Subject: A-7786 Hydraulic Clutch Release Yoke – Improved Seal Retainer

Document Number: TAIB0853

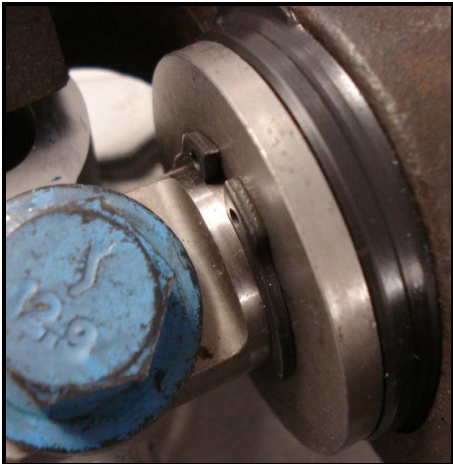
Issue Description: The integral hydraulic clutch release yoke assembly A-7786 contains two seals that keep clutch dust and contaminants out of the center pivot bearing area. Seals can become dislodged from the side spacer and fall down to the pivot shaft.

Corrective Action: A new side spacer, with an increased shoulder diameter for improved seal retention, was implemented in production 09/18/2014. The service part number A-7786 will not change.

Field Strategy: Currently the release yoke is not serviceable. Replace with the complete service assembly A-7786 if the side seals are not in place or are damaged.
